ADDENDUM NO. 1

DATE: June 26, 2015

Contract 14-C-00042; Melrose Pump Station Rehabilitation

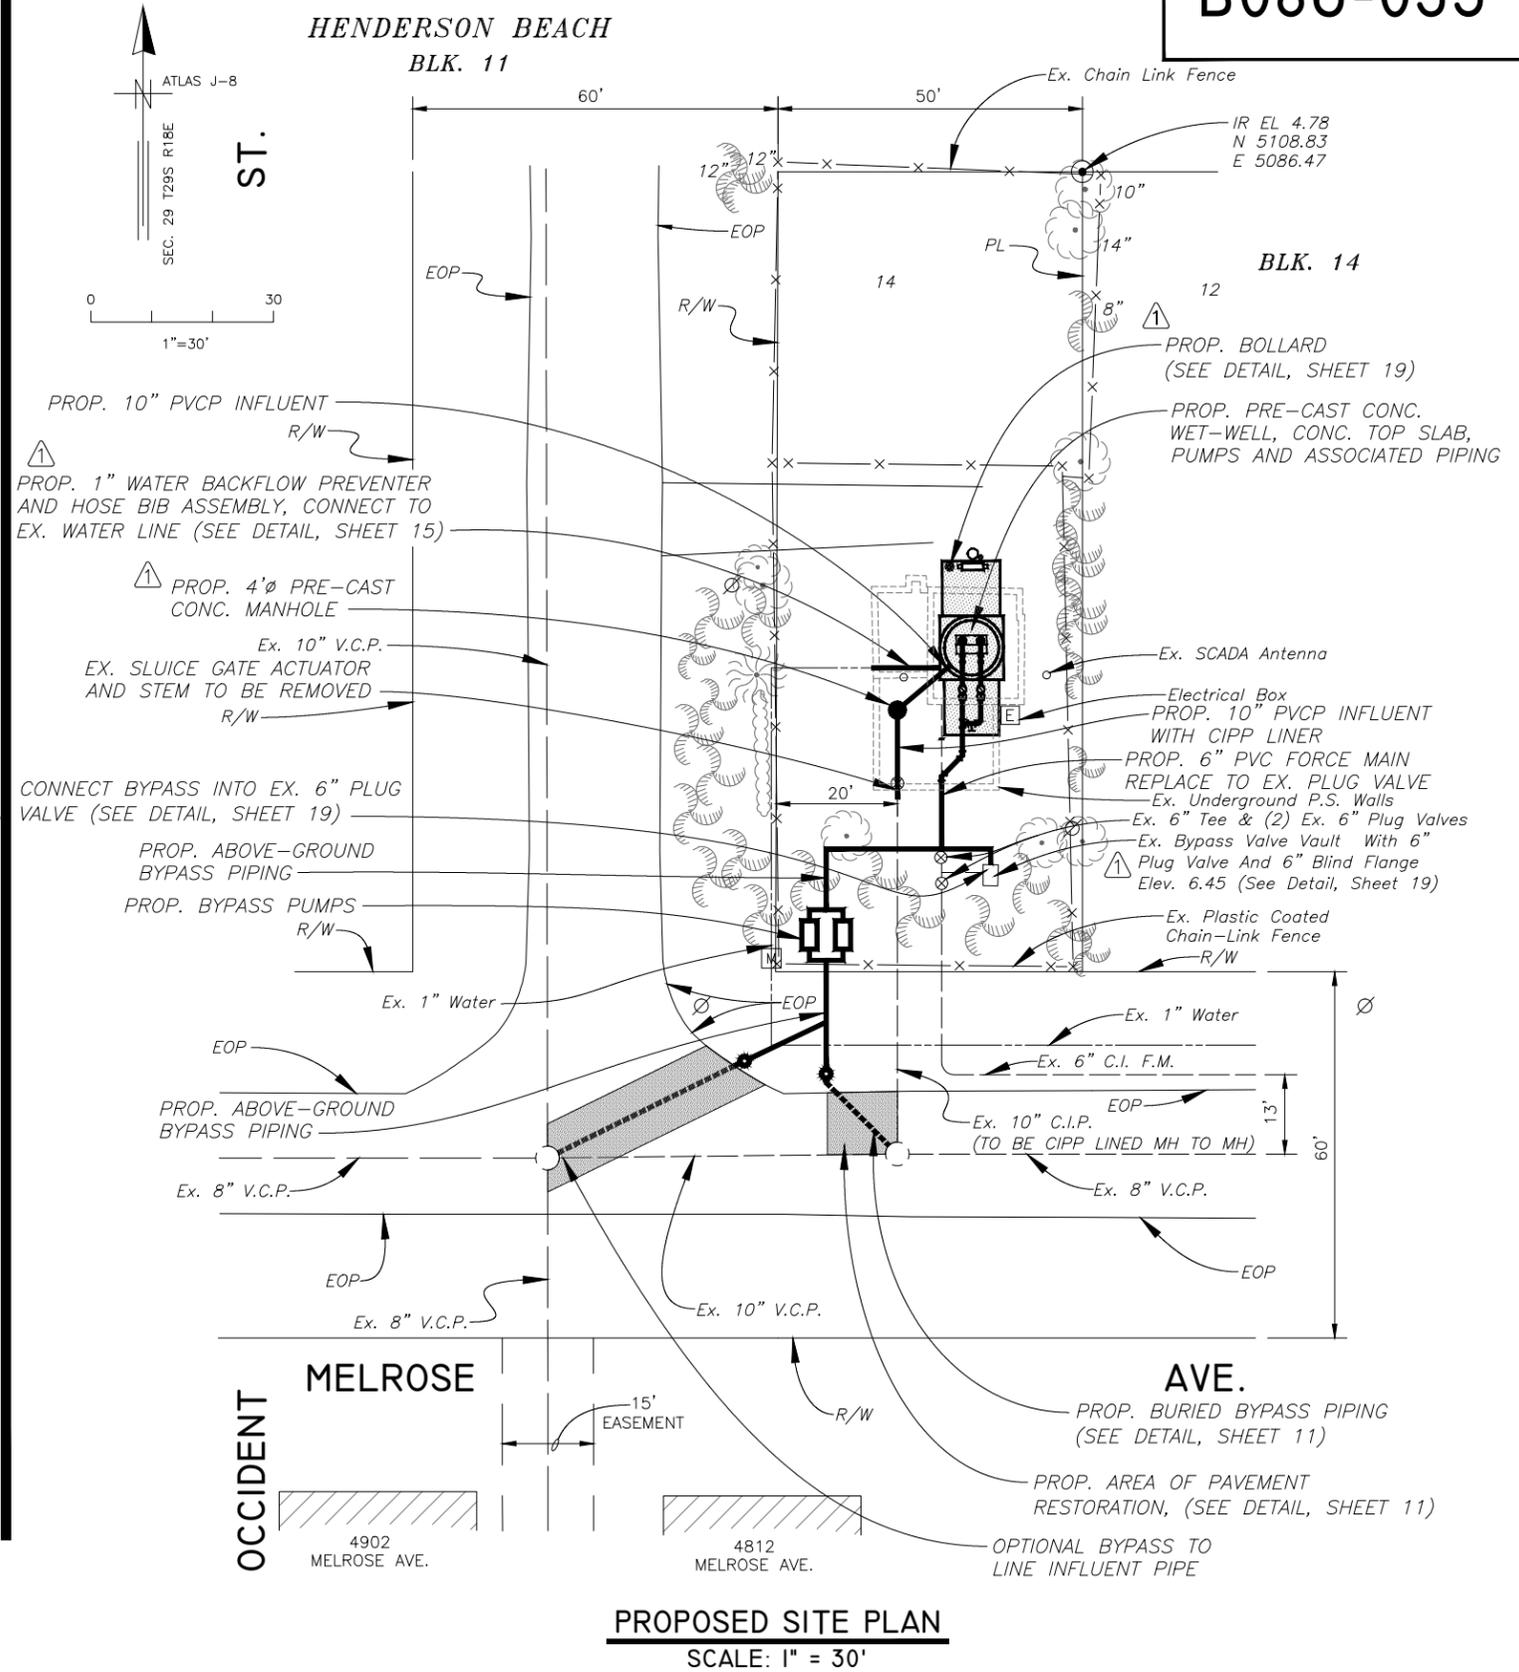
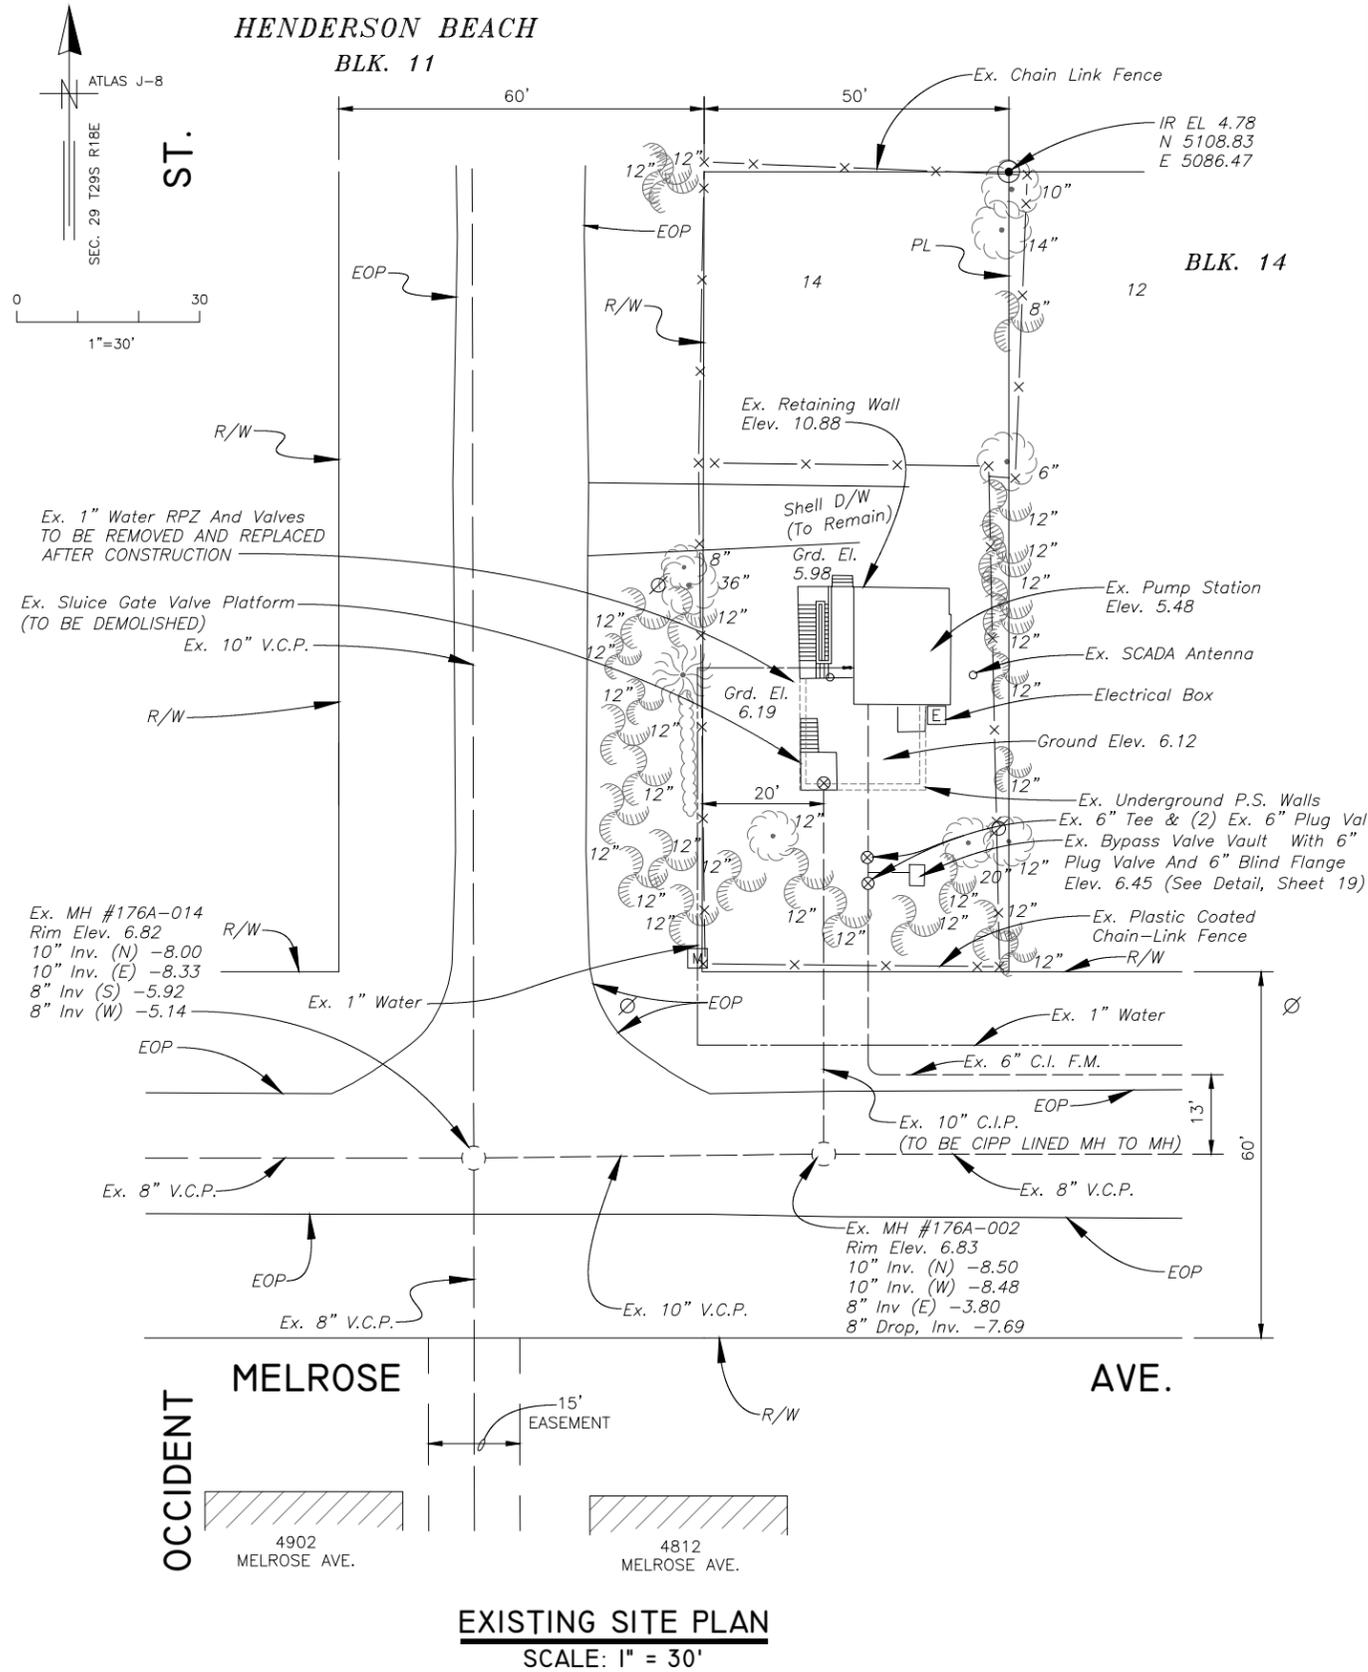
<table><tr> <th>No.</th> <th>DATE</th> <th>REVISIONS</th> </tr><tr> <td>1</td> <td>06/26/15</td> <td>ADDED NOTE D-5, REVISED NOTES D-1, G-26, G-29 & B-4</td> </tr></table>

MELROSE AVE. PUMPING STATION
REPLACEMENT
EXISTING AND PROPOSED SITE PLANS

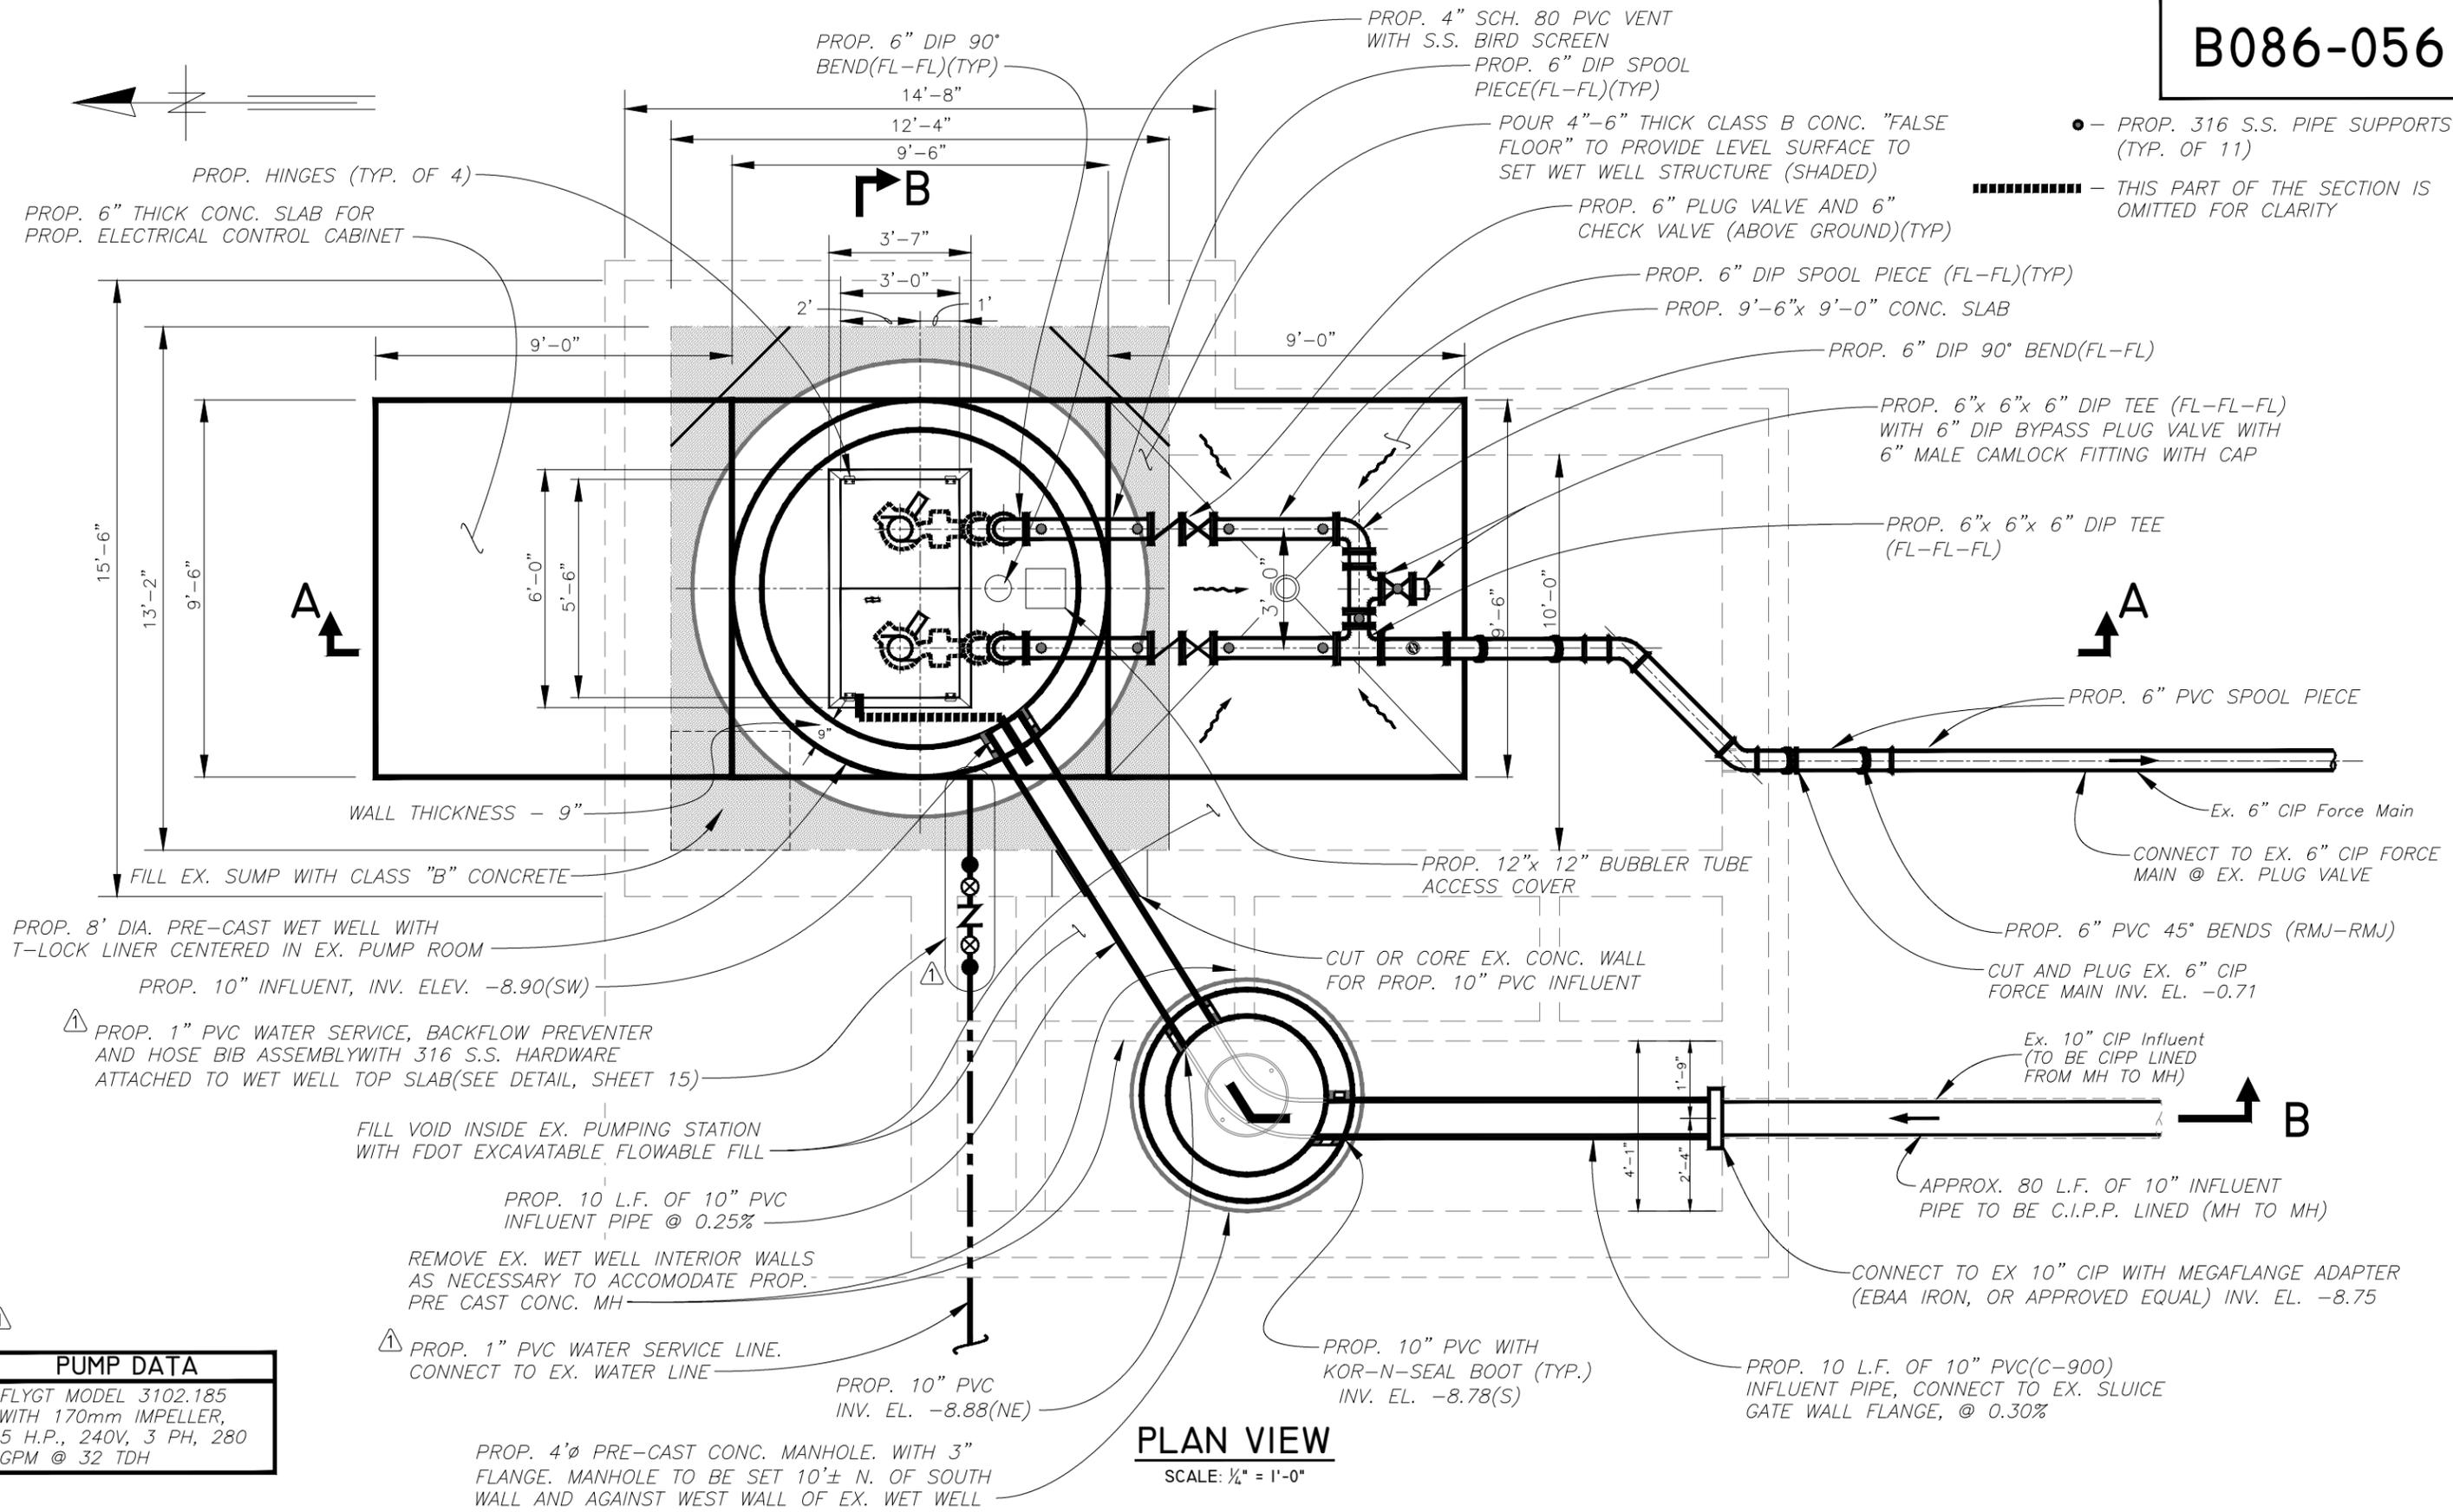
No.	DATE	REVISIONS
3		
2		
1	06/26/15	REVISED MANHOLE TYPE, WATER CONNECTION, AND BYPASS CONNECTION
